2023MY
Sportage (NQ5a)

256 (Rev 1, 06/03/2022)

TECHNICAL SERVICE BULLETIN

SERVICE ACTION: TRANSMISSION WIRE HARNESS
UPGRADE AND RELATED DTC P07XX, P0880 (SA499)

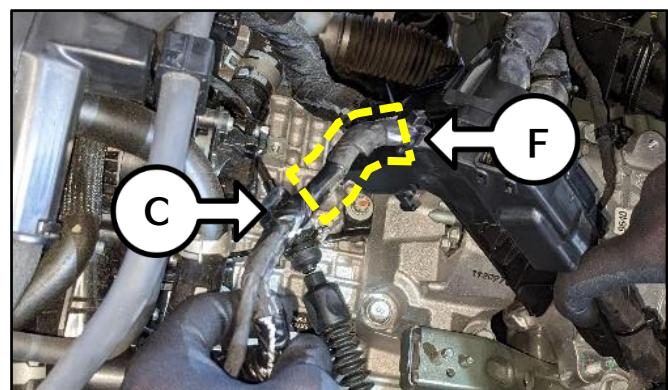
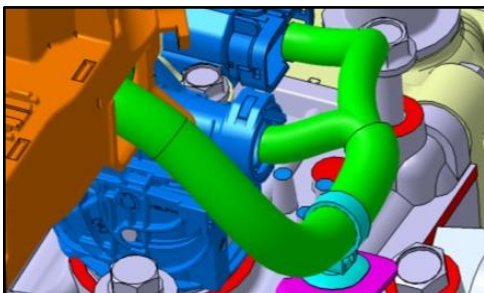
4. Locate the repair area shown between the harness clip (C) and zip tie (F).

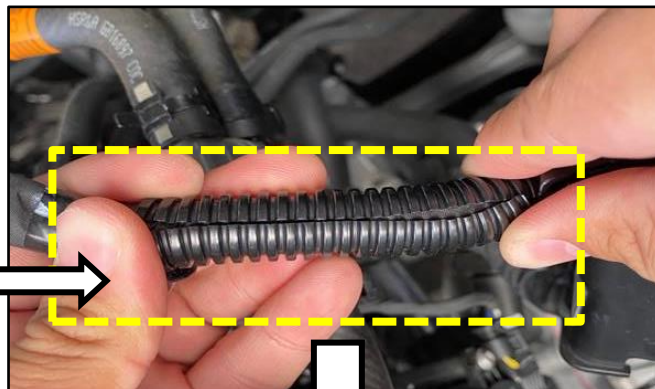
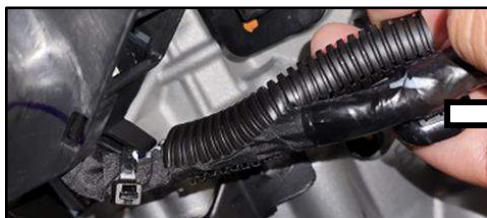
If damage to the wire insulation is found, wrap the affected wire(s) with electrical tape prior to continuing with the repair procedure below.

- Cut a piece of the plastic conduit flex tubing to 90mm (3.5" inch) in length.

Note: Use high temp (275° F) ½" inch (13mm) plastic conduit flex tubing.

- Cover/wrap the repair area of the control harness using the plastic conduit tubing as shown.

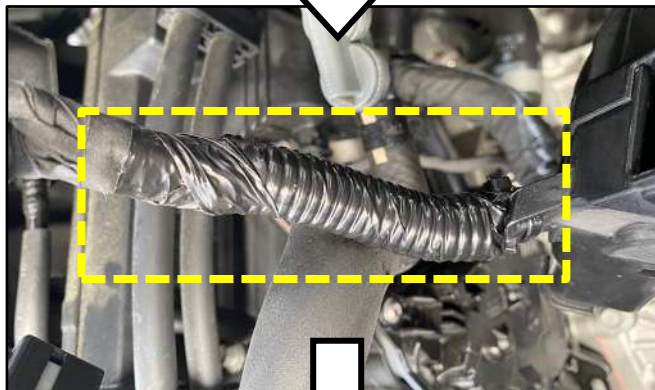
- Adhere high-temperature 3M™ electrical tape around the entire length of the plastic conduit tubing as shown.
- Reinstall all removed parts in the reverse order of removal.

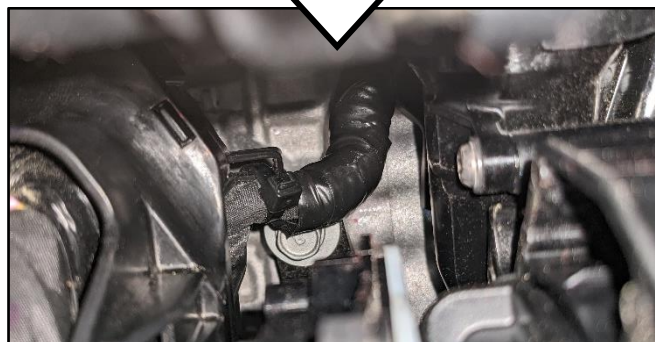
- Confirm that the control harness is not in contact with the shift cable bracket bolt and normal operation of the vehicle.
